## **BID ADDENDUM NO. 02**

**Date: March 26, 2026**

# **Bridge Classroom Portables – Multiple Sites – Lakewood Elementary School**

PBK Project No.: 250048

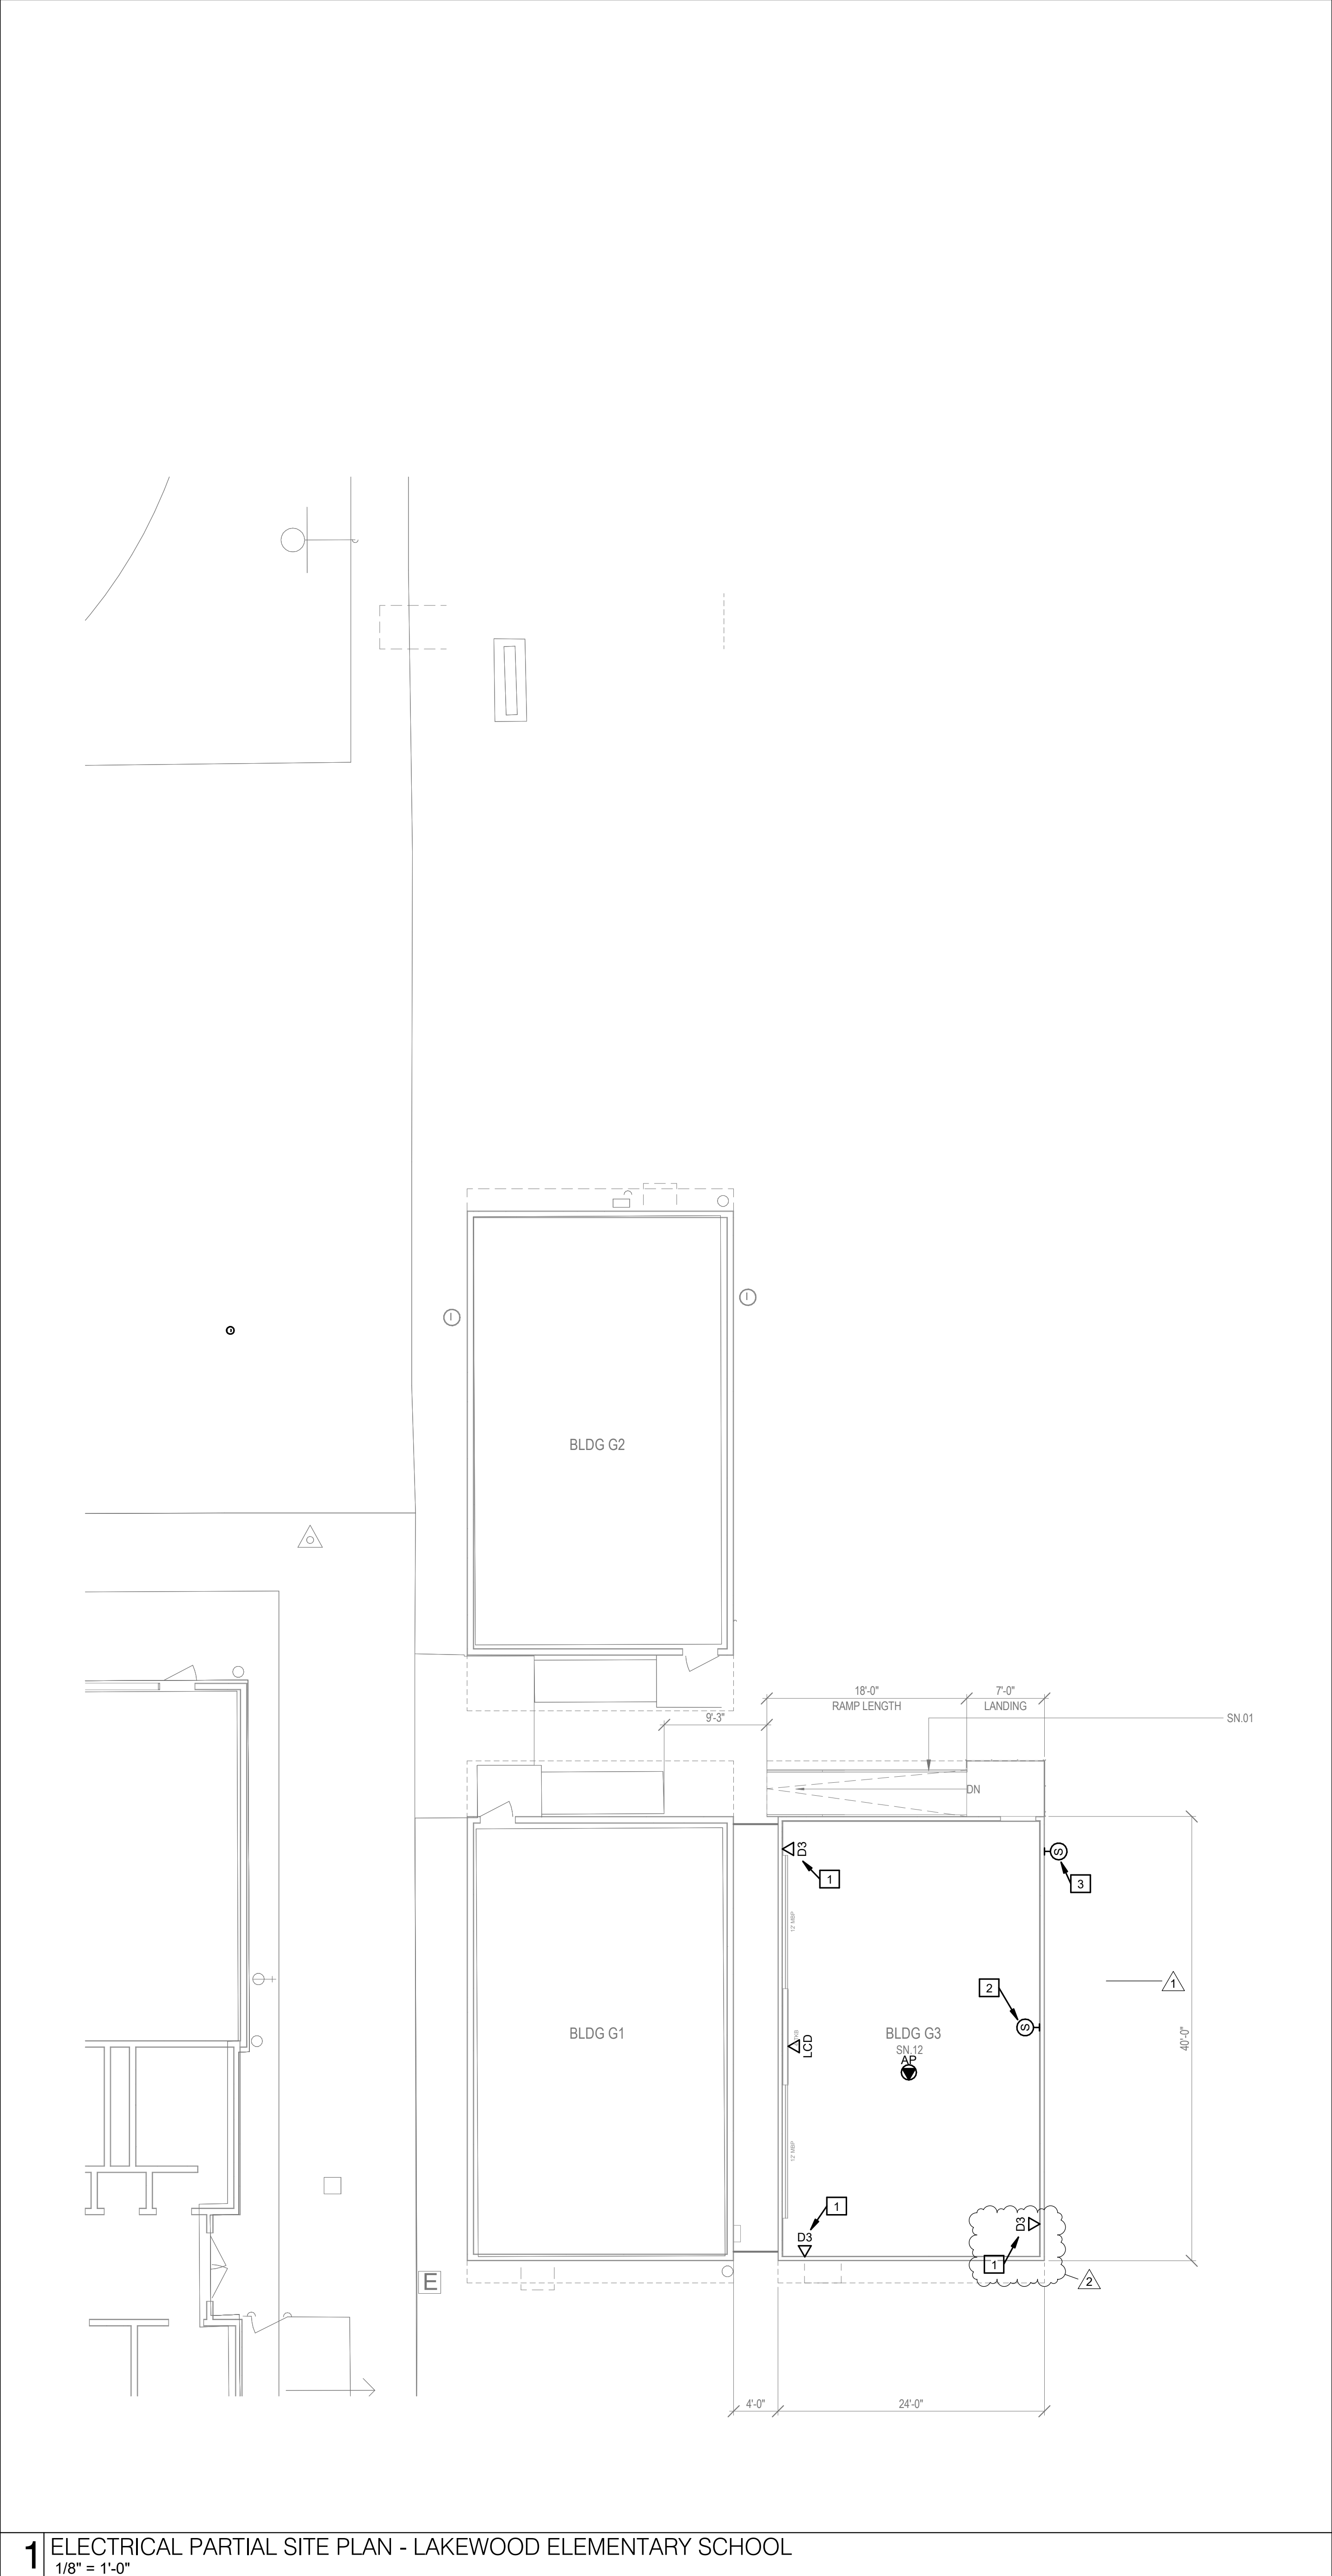
**Item No. 01** Replace in its entirety Technology Drawing T201. Location of data port has moved.
